ADDENDUM NO. 1

City of Spring Valley, MN
Wastewater Treatment Facility Improvements
Bid Date: October 27, 2026
Bid Time: 2:00 PM
BMI Project No. 0M2.131536

7.28

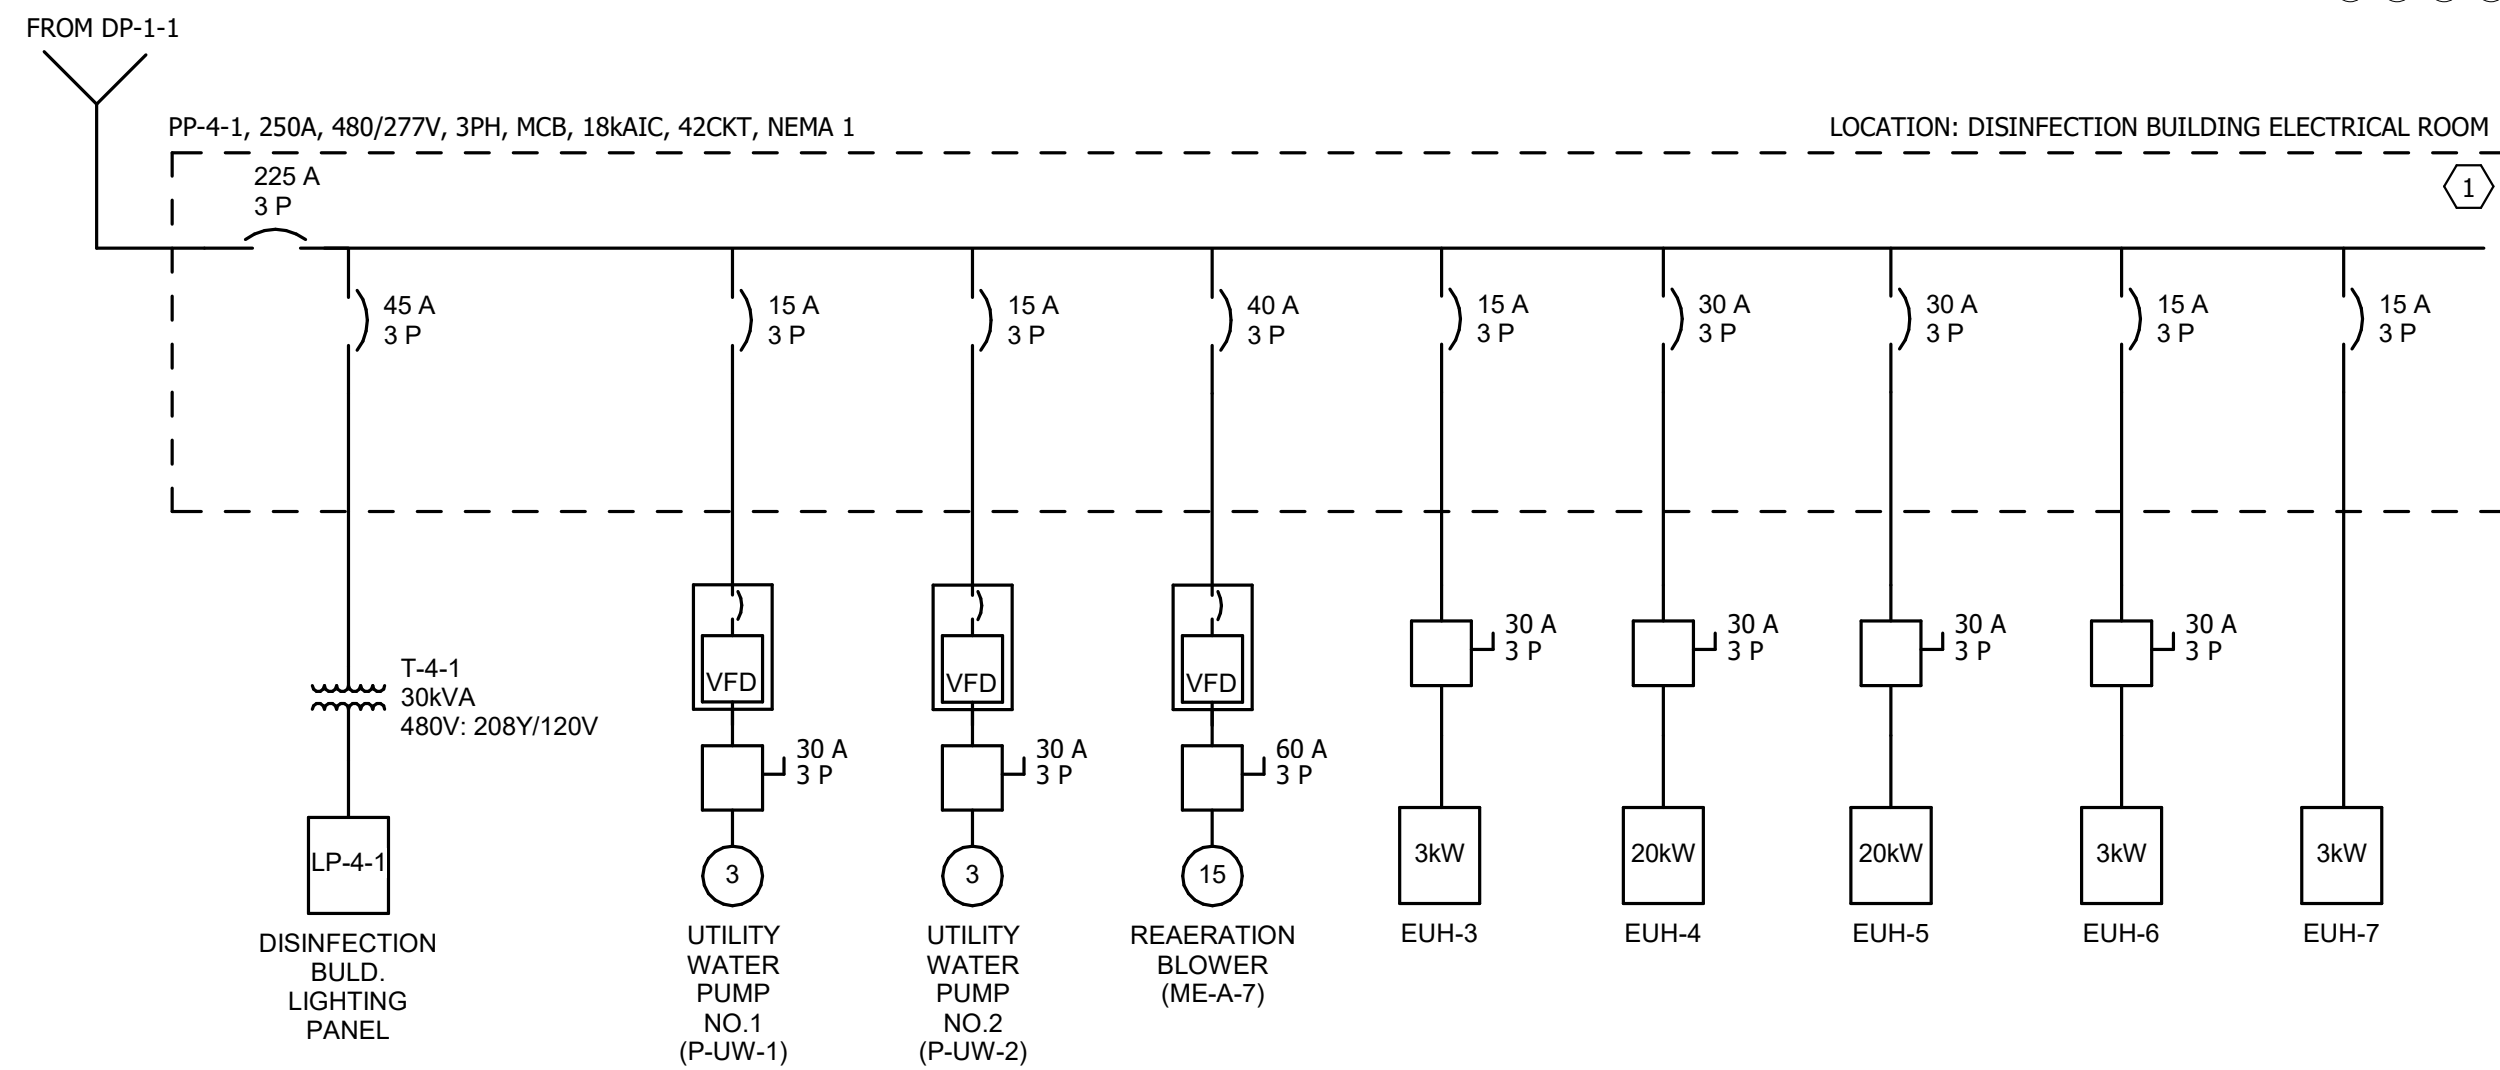
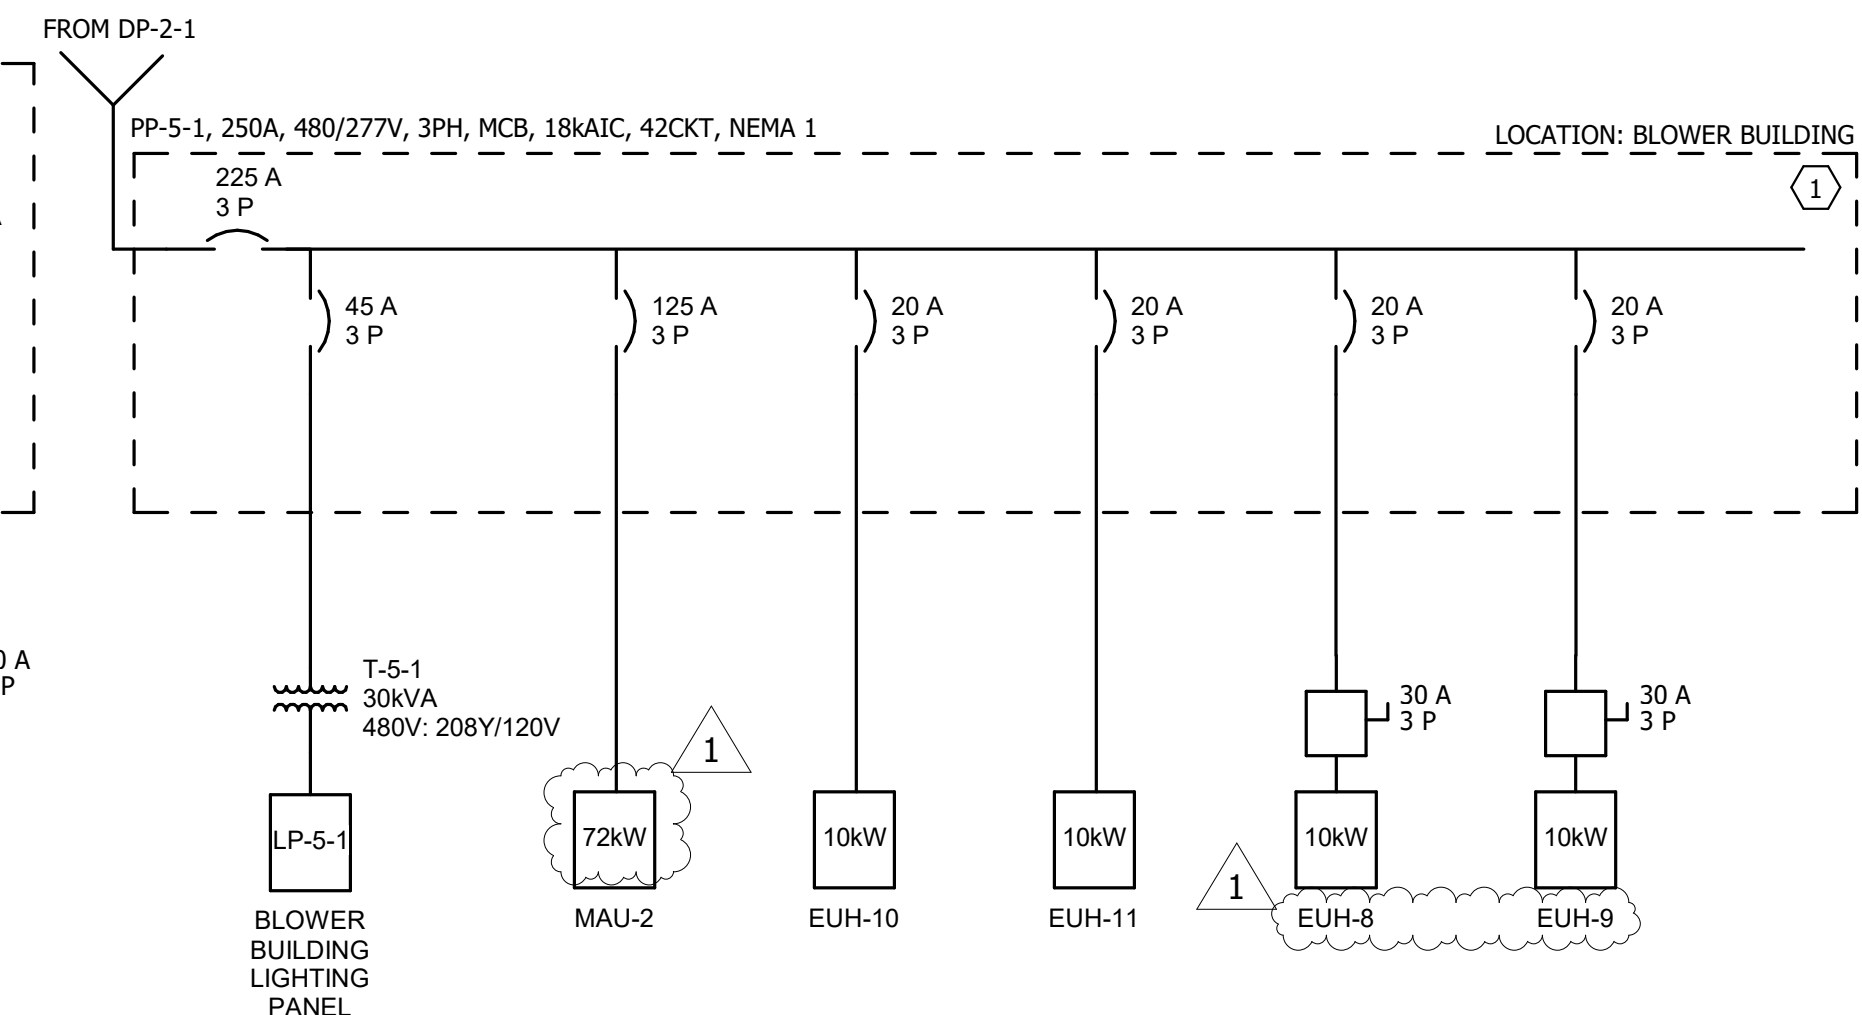
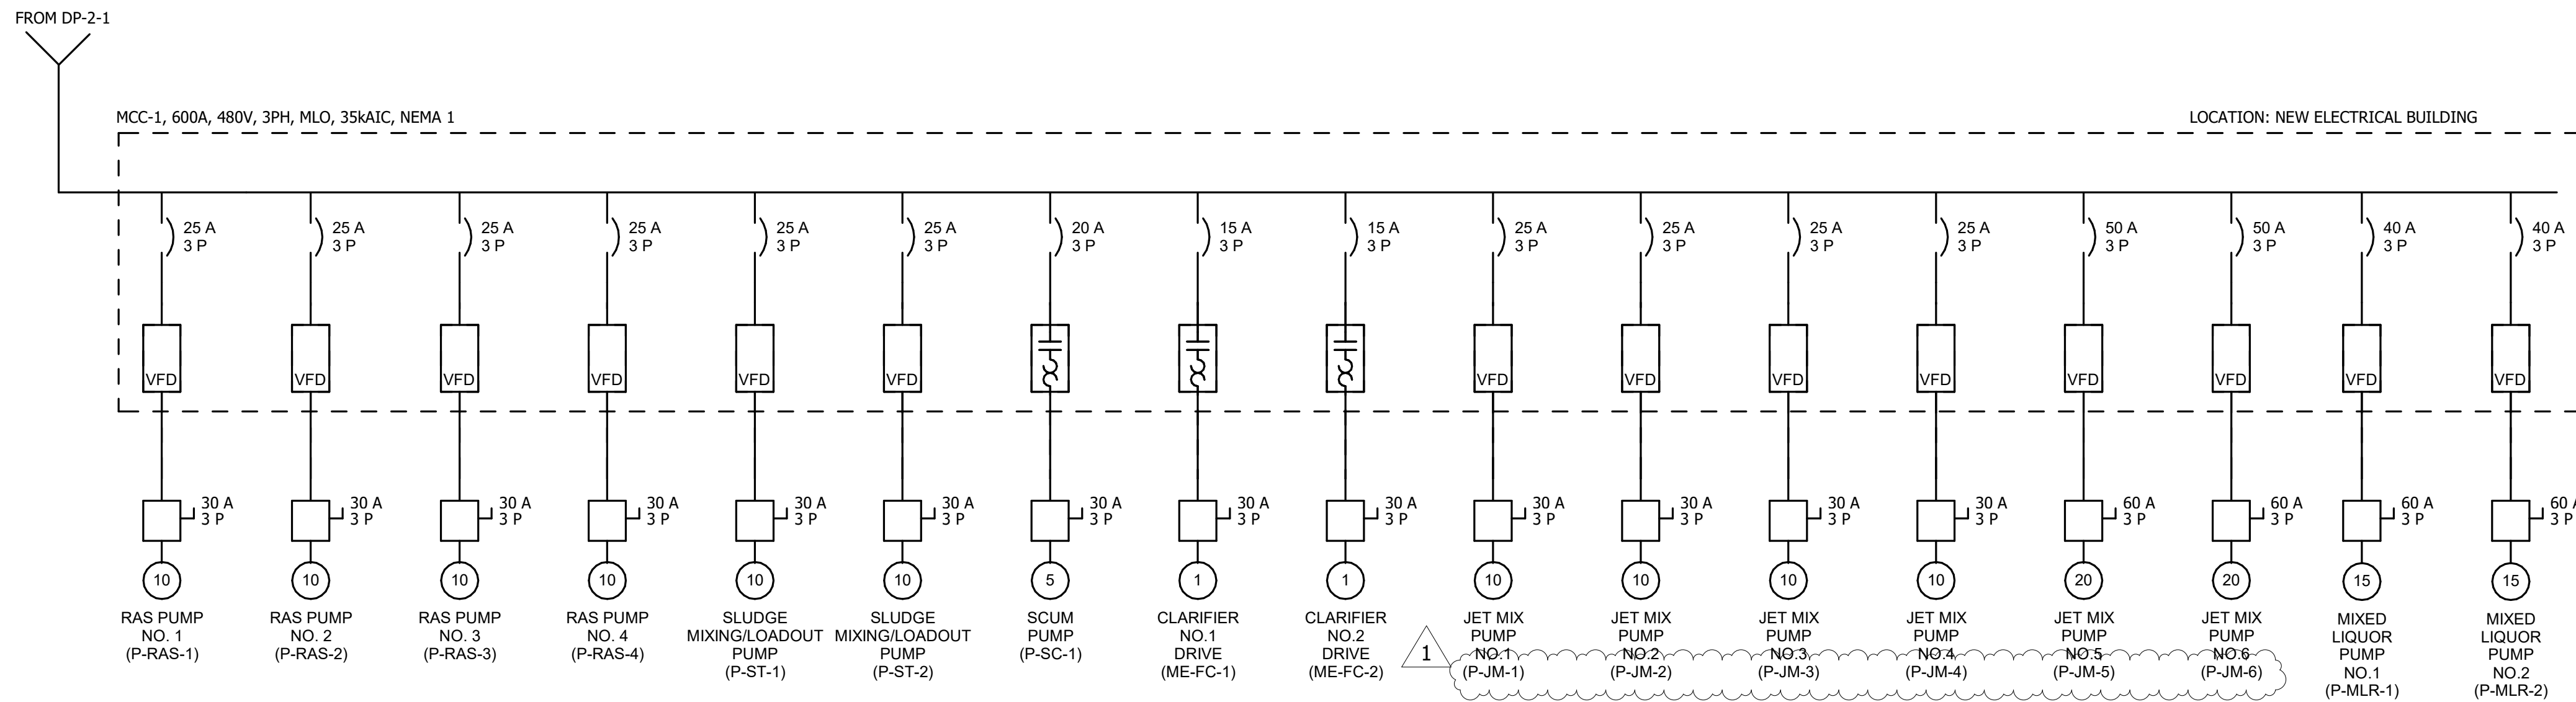
- a. Replace Sheet 7.28 Rev 0 09/29/2026 with attached Sheet 7.28 Rev 1 10/08/2026.
 - b. Revise jet mix pump abbreviations.
 - c. Revise MAU-2 to 72KW.
 - d. Rename electrical unit heaters EUH-8, EUH-9.

6 AERATION BASIN INSTRUMENT MOUNTING DETAIL
NO SCALE

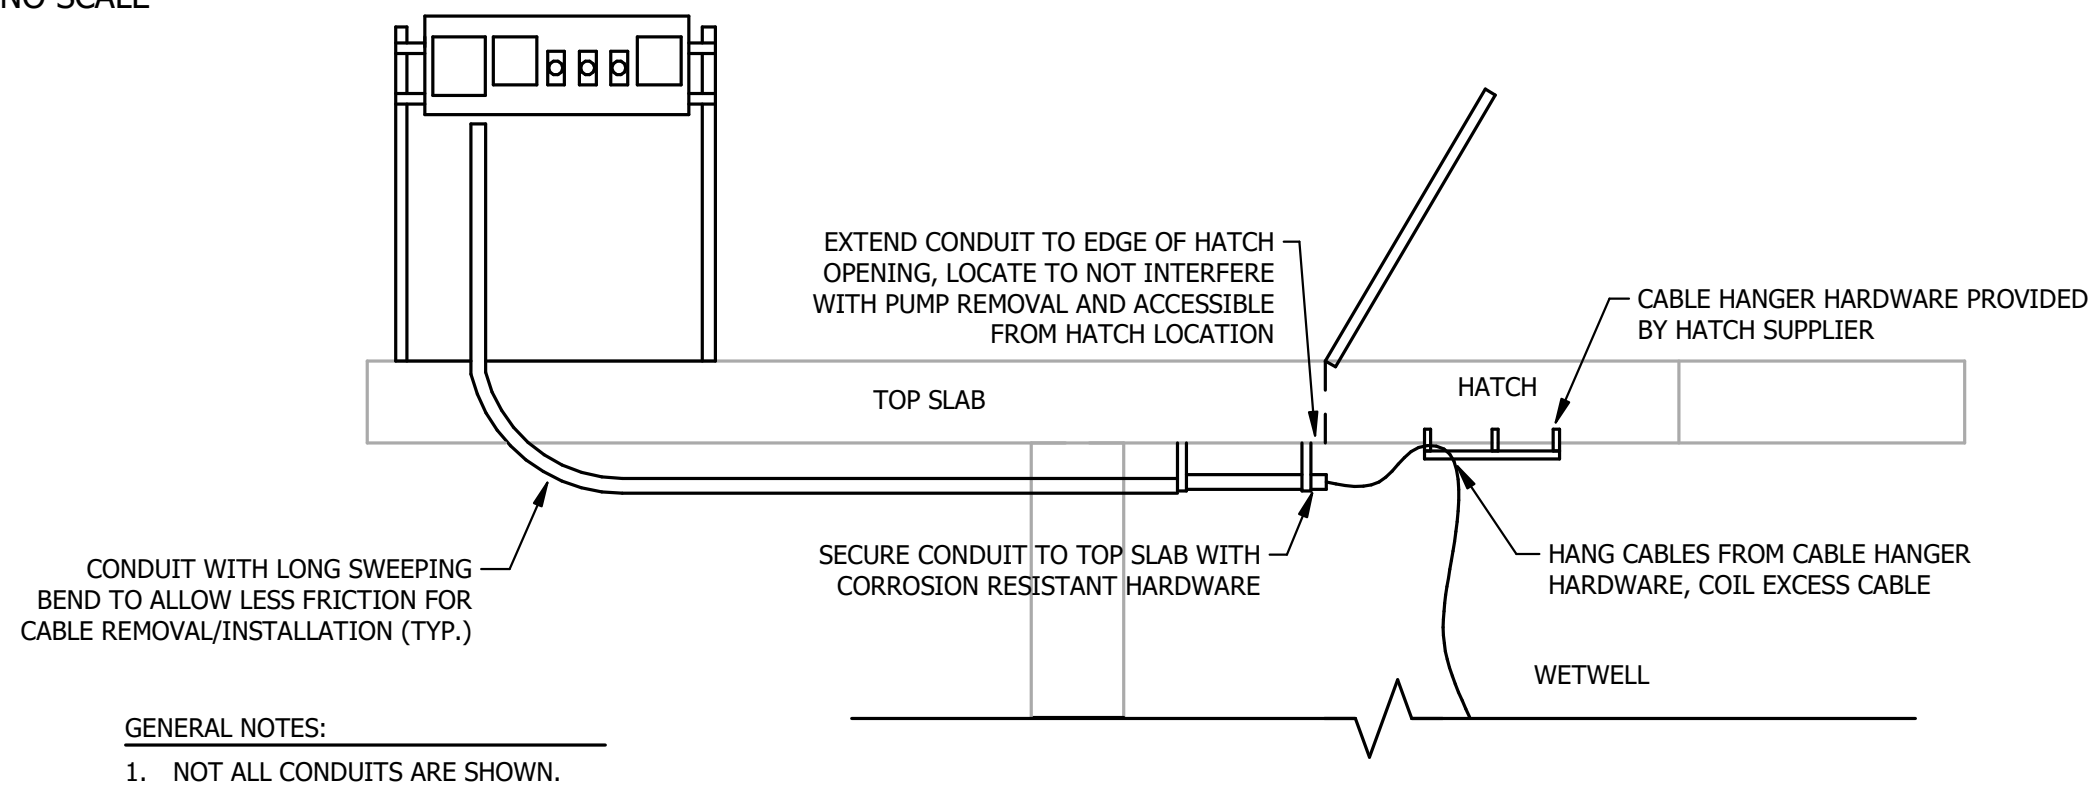
- Item II.1.21 Sheet 7.31 – Electrical Details**
- a. Replace Sheet 7.31 Rev 0 09/29/2026 with attached Sheet 7.31 Rev 1 10/08/2026.
 - b. Add WP Duplex receptacle to detail #6.
